31 March 2025

Re - Casey Fields South (Employment) and Devon Meadows
Precinct Structure Plan
1360 - 1370 Ballarto Rd, Clyde

Figure 3: From Plan 9 Infrastructure and Staging Plan

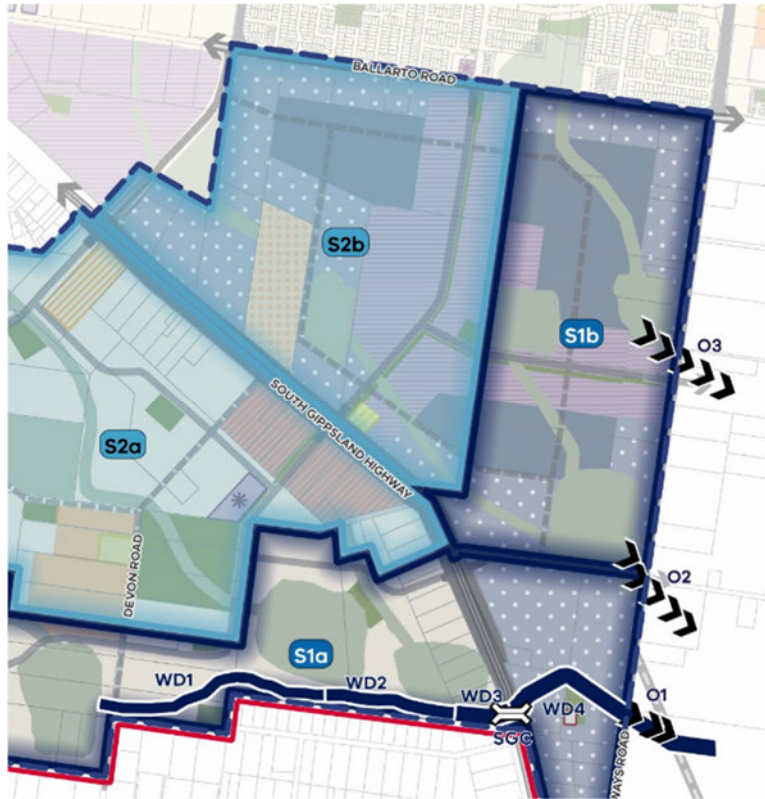
- Our client strongly oppose the proposed staging of precinct development which places the subject land within Stage 2. The proposed boundary between Stage 1 and 2 is arbitrary, running along the boundary of a neighbouring site. The boundary does not reflect drainage catchments which would otherwise provide for the logical development of the precinct.

Figure 4: Alternative staging proposal for precinct

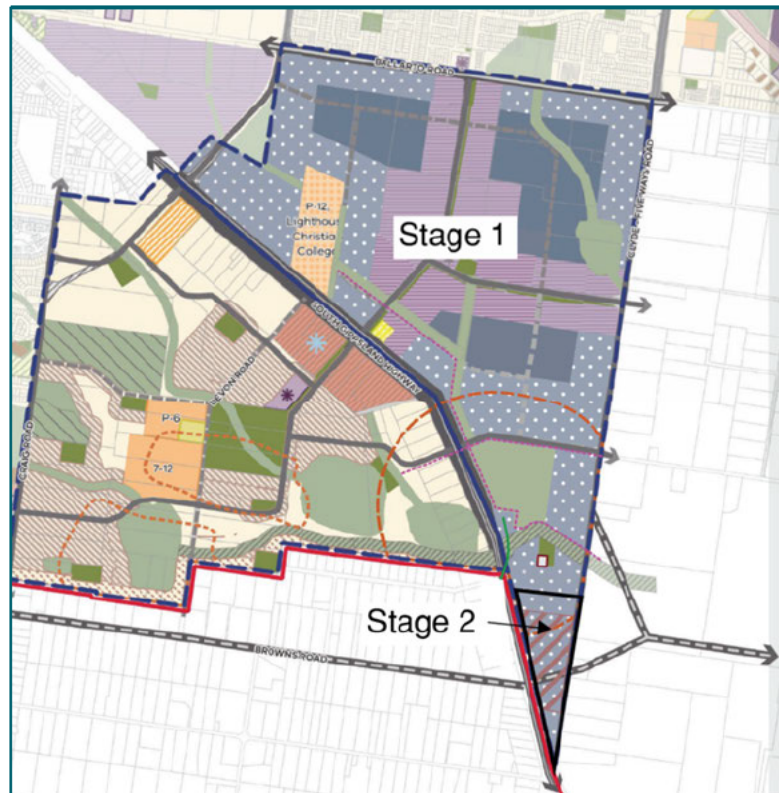
If the VPA is committed to staging the Casey Fields South precinct we suggest that the triangular Investigation Area to the far south of the precinct be nominated as Stage 2, given this area is yet to be given consideration and its development of this area will require:

- Resolution of the Clyde Fiveways intersection, and
- Construction of the Browns Road extension to Clyde.

Stage 1 as proposed in this submission contains two drainage catchments with proposed outlets O1 and O3. The necessity for a downstream outlet will effectively guide the development of the two catchments within the proposed Stage 1 precinct but does not otherwise need to be restrained by a stage boundary.

Figure 5: Movement network plan with additional east-west Connector Street indicated in orange dash

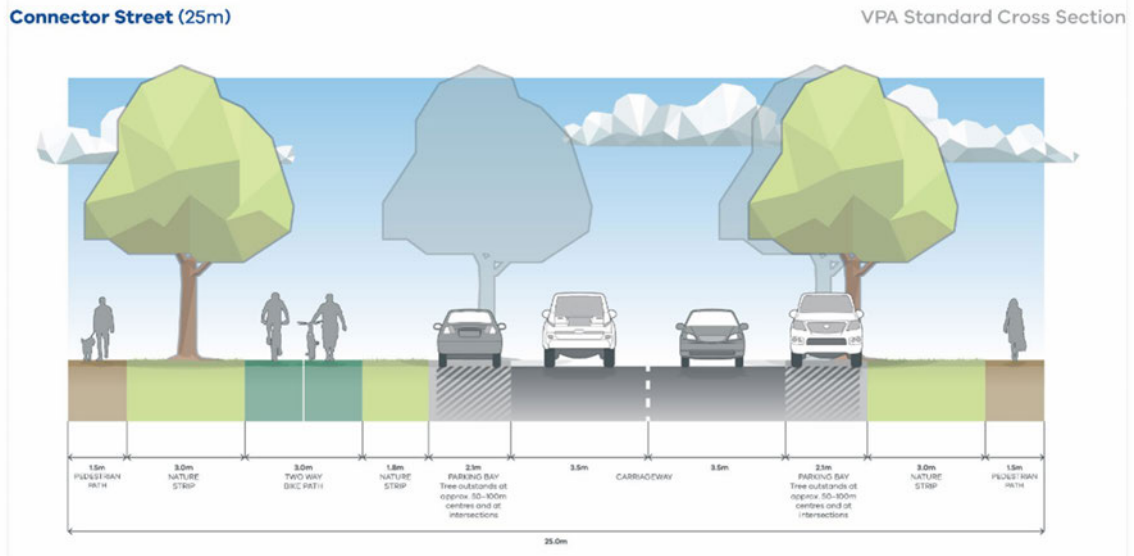
- Buncha Flowers generally supports the proposed road network but suggests the proposed east-west Local Access Street through the site be upgraded to a Connector Street to improve precinct access to the future Casey Fields Boulevard, as indicated in the image below

- Buncha Flowers supports the application of the 25m wide cross section with parking on each side of the road to the alignment indicated in Figure 5, as below.
